LTB00823NAS2

TECHNICAL BULLETIN

204-01: Front Suspension

'Creak' Noise From Stabilizer Bar Bushing-Front

E182199

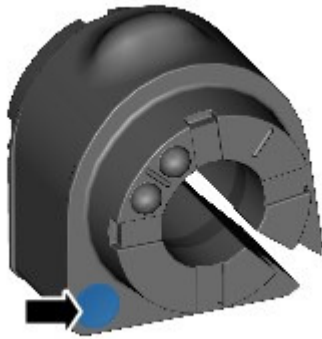
Lubricant must NOT be used when installing the new stabilizer bar bushing-front.

The new stabilizer bar bushing-front can be identified by a YELLOW painted dot in the area shown.

Install new stabilizer bar bushings-front (see TOPIx Workshop Manual section 204-01: Front Suspension - Front Stabilizer Bar Bushing).
